NB11231 - Peer Review - r02.docx

St Vincent's Research Precinct Traffic and Parking Review

The NSW Department of Planning (DoP) engaged Sinclair Knight Merz (SKM) to review the traffic and parking assessment of the proposed St Vincent's Research Precinct, incorporating the Garvan St Vincent's Cancer Centre (GSVCC), the Victor Chang Cardiac Research Institute (VCCRI), the Garvan Institute of Medical Research (the Garvan Institute), and the Centre of Applied Medical Research (CAMR), and the proposed Stage 2 building in the northeastern corner of the site, in Darlinghurst. The traffic and parking assessment was undertaken by TEF Consulting, who reported in February 2010. TEF Consulting is a consultant to the Garvan Institute and St Vincent's and Mater Health Sydney, the proponents of the Research Precinct.

Figure 1: Swept path analysis of the proposed widened driveway access on West Street (undertaken by Darlinghurst Residents Action Group).

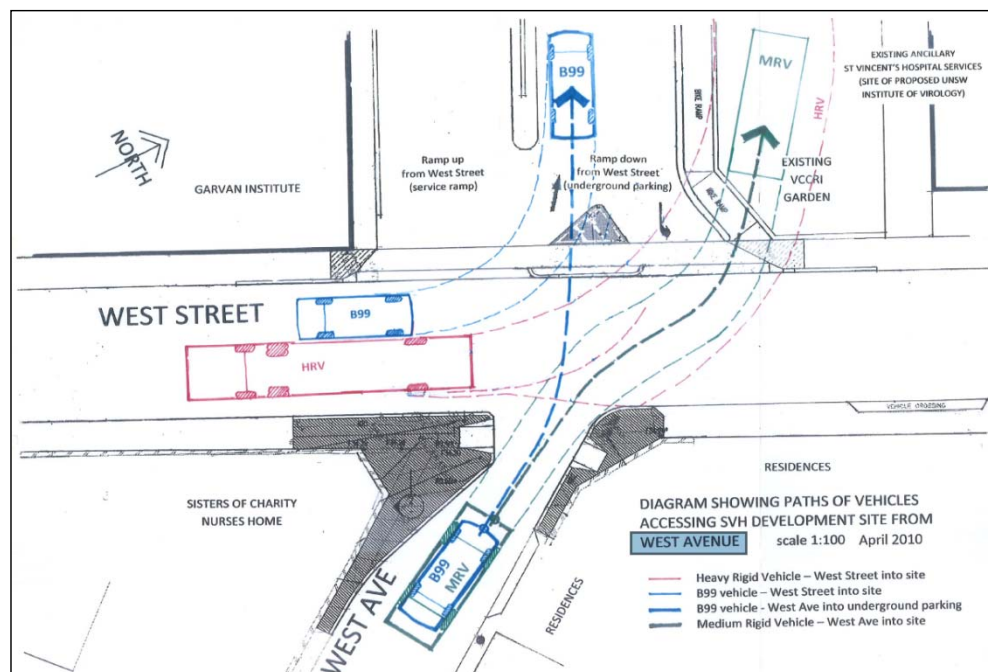
- A previous approval for the site required traffic management measures at the intersection of West Avenue and West Street to prevent direct access from West Avenue to the access driveway to the car park and loading facility. Residents are concerned that with the proposed driveway to the north of the existing basement access, vehicles will be able to access the driveway illegally from West Avenue, as evidenced by the swept path shown in **Figure 1**.

Access to West Street driveway via West Avenue – Access to Barcom Street (and hence West Avenue) is restricted by a 2 tonne limit for vehicles who do not have a destination within these streets. The combination of the uphill gradient, deflection to the right caused by the kerb blister, and limited sight distance to the left on the West Avenue approach to the intersection are considered sufficient deterrents to the majority of vehicles from accessing the car park from West Avenue. It is understood that the additional access located immediately to the north of the existing West Street access is intended to operate as an access to the loading dock. Consequently, the majority of vehicles using this access would be service vehicles. Service vehicles are not permitted to use West Avenue, for the reasons discussed above, and could not approach the new loading dock access via West Avenue.

Therefore, it is considered that increased traffic volumes on West Avenue as a result of the GSVCC and the proposed Stage 2 building would be minimal.

- **Figure 2: Proposed access arrangements**

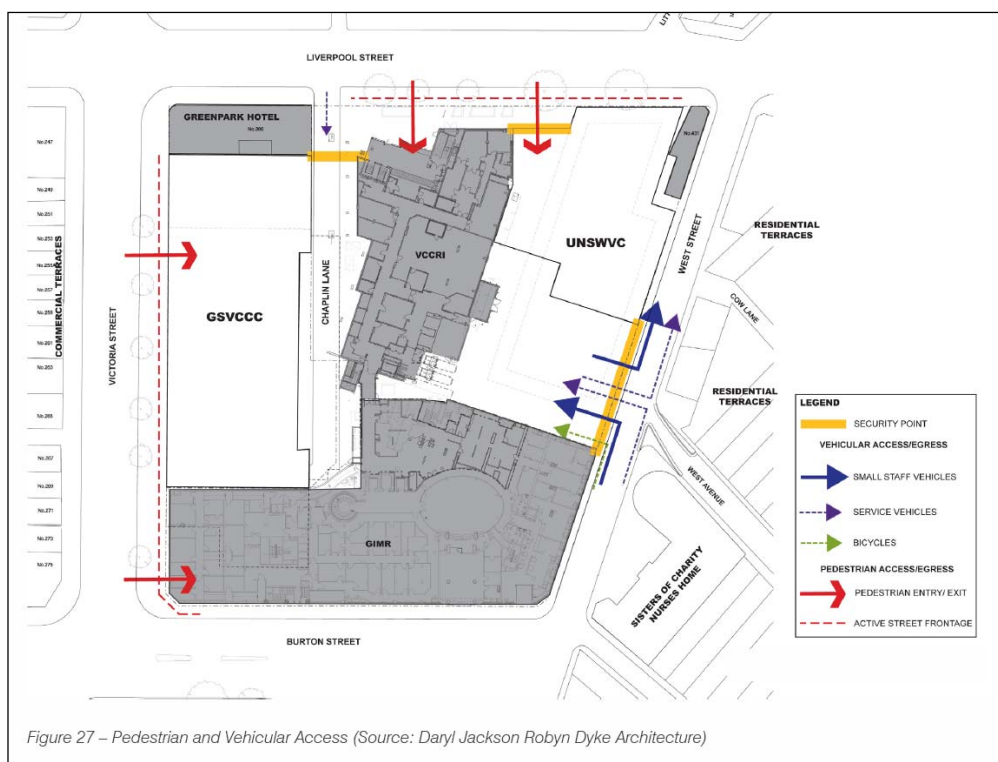
- **Vehicle Access** – Access to the precinct is proposed to be via the existing access on West Street, with access to the underground Stage 2 building and GSVCC parking to be via underground connections. Chaplin Lane is proposed to be used for light service vehicles and rear loading to the Green Park Hotel. Proposed access arrangements for the precinct are shown in **Figure 2**.

It is recommended that Chaplin Lane operate as left-in and left-out only, as right turns from Liverpool Street to Chaplin Street are considered unfeasible, as they would likely cause queuing at the Liverpool Street / Victoria Street intersection (which is located approximately 30 metres west of Chaplin Street). The City of Sydney proposed that an access off Victoria Street be considered. A second access off Victoria Street is not considered preferable, given the concentration of activity along Victoria Street with regard

to kerbside parking, high pedestrian volumes, and moderate traffic volumes (approximately 12,000 vehicles per day). West Street is a less active street and provides safer entry and egress for vehicles accessing the precinct.
